KERALA STATE ELECTRICITY BOARD Ltd

Execution of Civil and Hydro Mechanical works of Hydro Electric Projects - Modality in the measurement of Tunnel lining - Modification in KSEB Data Book - Sanction accorded - Orders issued.

BO (FTD)No.389/2022(DGC/AEEII/General/22/2022)

Annexure to the B. O (FTD) No.38/2022 (DGC/AEEII/General/22/2022)
dated 04.06.2022

Indicative sketch showing proposed demarcation of Invert and Overt

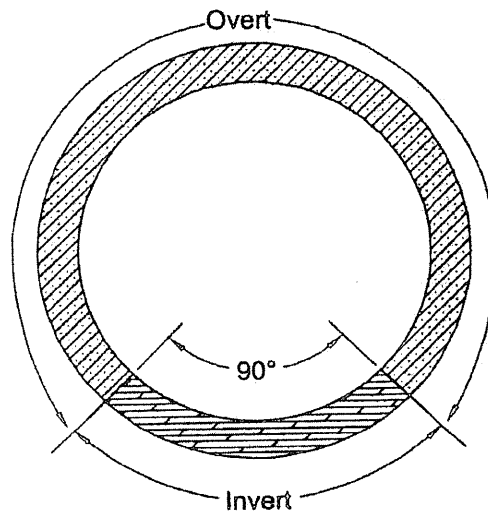
Resolved to amend the remark of invert overt classification for circular tunnels as 50% for invert & 50% for overt mentioned in the sanctioned KSEBL data book as follows and as shown in Annexure:

- for circular tunnels requiring concrete lining, the bottom 90⁰ be considered as invert and the balance 270⁰ as Overt (sides & arches)
- for flat bottom tunnels such as D- shaped tunnels, modified horse-shoe tunnels etc., the bottom flat or near to flat portion be considered as invert and the portion above this (sides & arches) be considered as overt.
